STATE OF MAINE  
DEPARTMENT OF TRANSPORTATION  
16 STATE HOUSE STATION  
AUGUSTA, MAINE 04333-0016

May 10, 2018  
Subject: Lisbon Center Bridge  
Replacement  
State WIN: 018970.00  
Location: **Lisbon**  
**Amendment No. 1**

**GIRDER REINFORCING**  
G1 AND G4

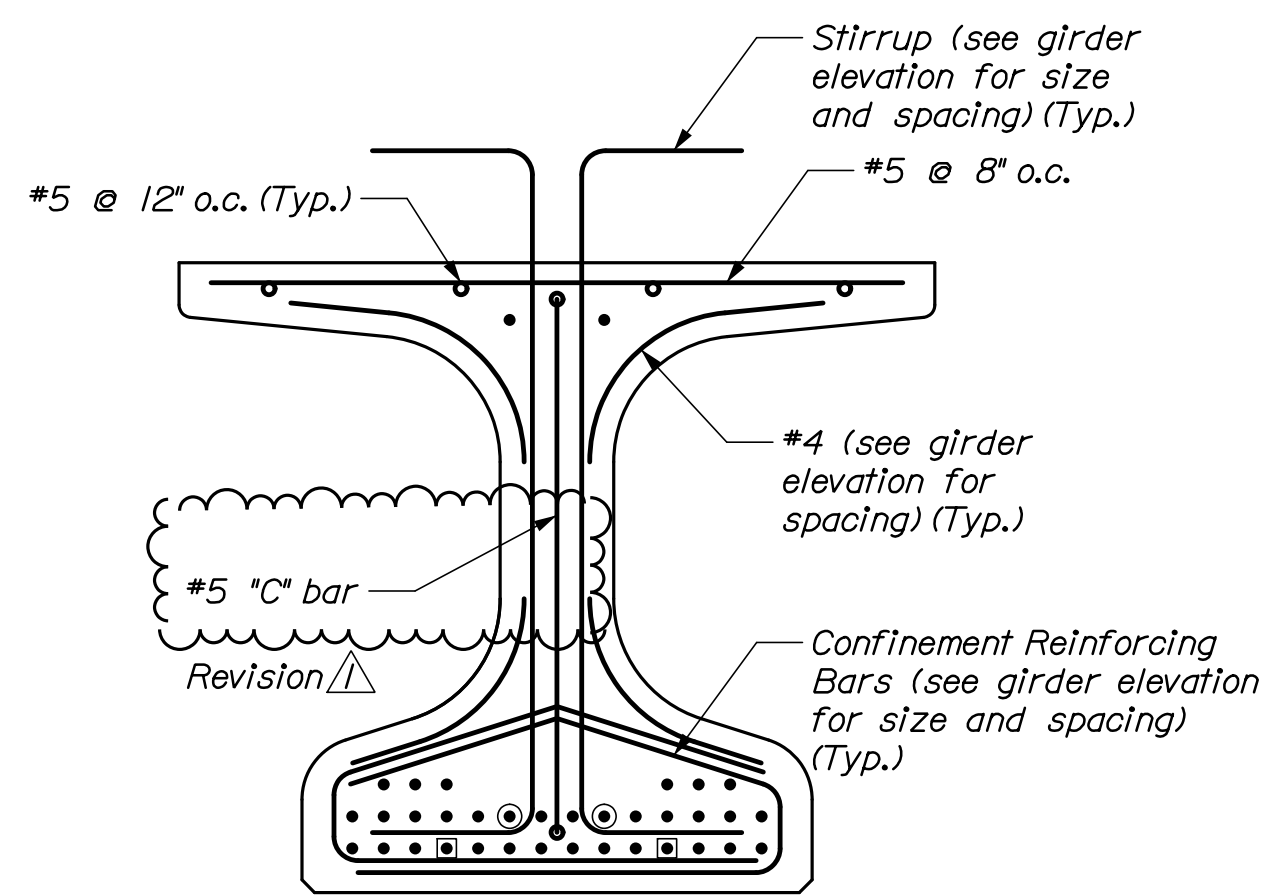
**Question:** On sheet 36 of 53 and 37 of 53 there is a detail showing the girder reinforcing for Girders G1 and G4, and G2 and G3 respectively. On the detail, it seems to show a vertical bar in the middle of the web of the girder. There are no details on the drawings indicating a size, shape or quantity of this bar. Can you provide clarification so we can get accurate pricing for reinforcing in these girders?

**Response:** Please refer to revised Sheets 36 and 37, Beam Details 1 and 2 respectively.
